EVEREST ENCLAVE SEC-13, GROUP HOUSING AT VINDAVAN SCHEME, LUCKNOW

DETAIL OF PLUMBING

DOMESTIC WATER TANK

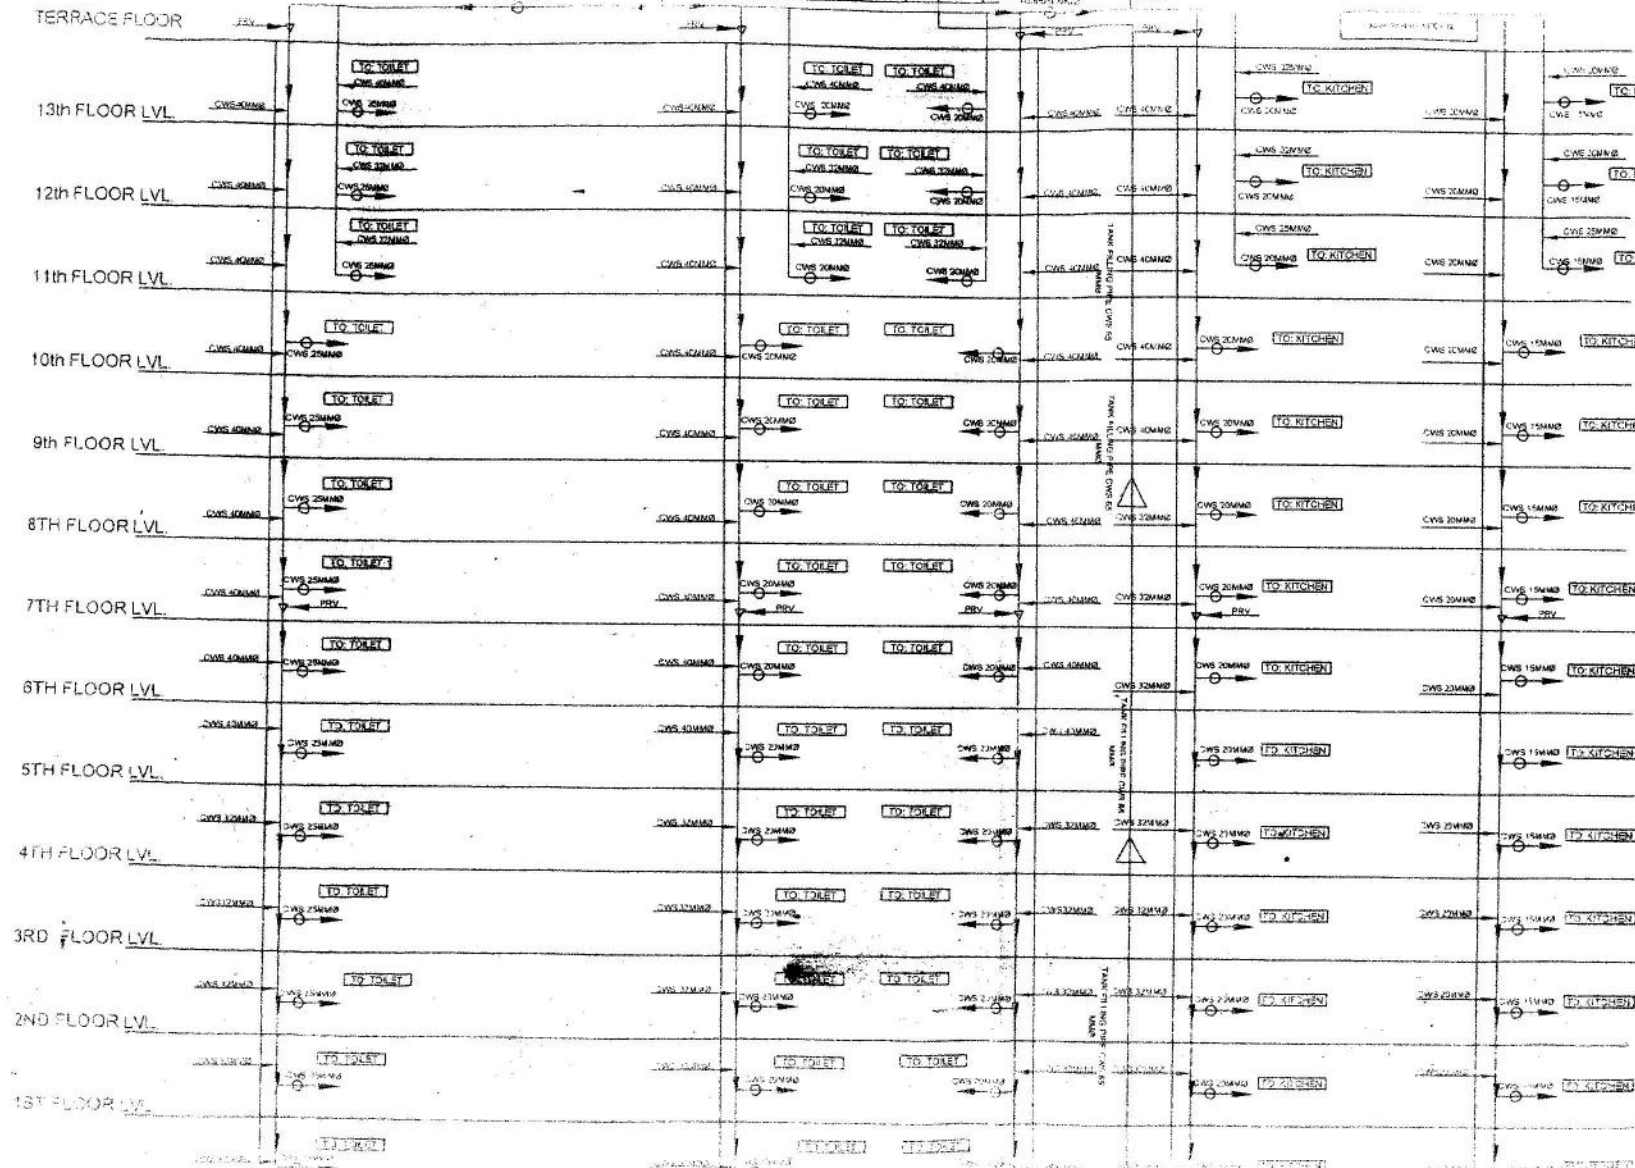
Booster pump is required for the 13th floor
